**RE: PART VIII – Renovation and Restructuring of the Tholsel Building
Planning & Development Acts 2000 – 2018
Planning & Development Regulations 2001 – 2018**

Chief Executives Report on the Consultation process
for the proposed
for the restructuring and renovation of
The Tholsel (City Hall)
High Street, Kilkenny.

May 2019

View of the proposed rear elevation

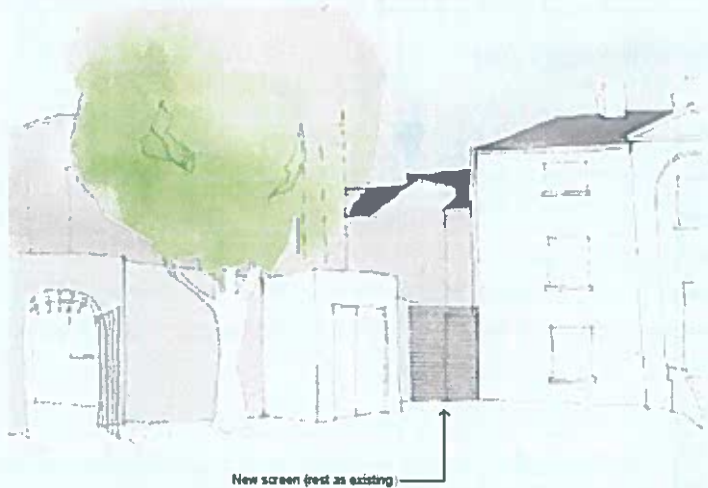
- e) The proposal to remove the clutter of disfiguring extensions at the rear of the building is very welcome. However, the proposed facade appears austere and obtrusive. Strongly recommend that windows similar to the old windows (reference Crawford Collection photo 1947) be installed. Recommends that the wall is painted in a colour that harmonises with the colour of the stone walls and slate roof. On balance feel that the copper roof will age elegantly.

- f) Rear extension: Welcomes the proposal to improve the visual impact of the eastern facade, however questions the addition of a modern white façade with frameless glazing and copper roofing is questionable, noting that many modern pale façades e.g. the east and north facades of the Court House, quickly stain with algae and age badly. An Taisce favours reinstatement of a rubble stone façade, the original roof profile covered with slates, and the window proportions and design shown in the photograph of the 'East facing elevation of rear of Tholsel, 1947' from the Crawford Collection. Such a façade would be entirely in keeping with the aesthetics of the building and would age well. We accept the practicalities of placing the stairs and lift at the rear and we hope a new home can be found for the ceremonial staircase in a public building.

b) Object to modifications to the rear (eastern elevation).

b) Objects to modifications to the rear (eastern elevation), making the suggestion to "...work with what's there"
